# SERVICE PROCEDURE

G-07503 March 2007

**SUBJECT:** SAFETY RECALL (U.S., EXPORT)

SIDE EMERGENCY DOOR HOLDBACK on certain CE.

Figure 1

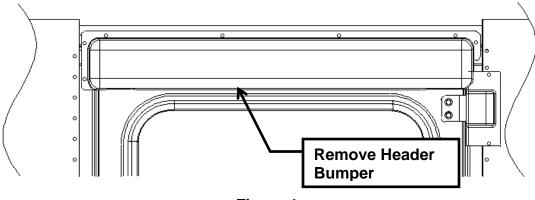
1. Remove the **side** emergency door head bumper.

Figure 2

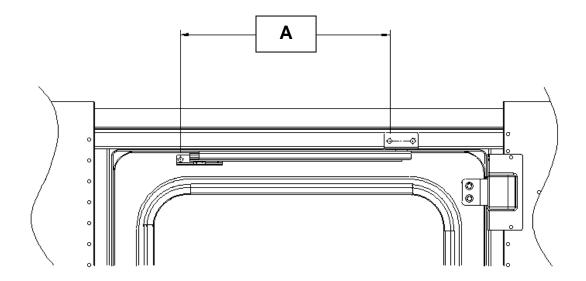
2. Measure dimension **A** on the hold back mechanism bolt pattern indicated below:

- a. If dimension **A** is *13"* (330mm) or *greater*, then no further action is necessary, re-install header bumper.
- b. If dimension A is *less* than 13" (330mm), continue on to step 3.

Figure 3

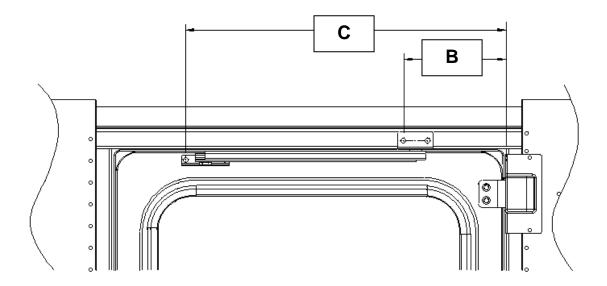
- 3. If dimension A is less than 13" (330mm):
  - a. Remove bolts from holdback mechanism.
  - b. Measure location for new hole using Nominal dimension from Table 1. *Measure from door frame surface, not hinge surface.*
  - c. Drill hole with #5 drill bit.
  - d. Use holdback bracket as a template to mark and drill second holes.
  - e. Reinstall holdback mechanism using existing hardware.

<u>Dimension</u>	<u>Nominal</u>	
В	<b>6.5</b> " (165mm)	
С	<b>20.375</b> " (517mm)
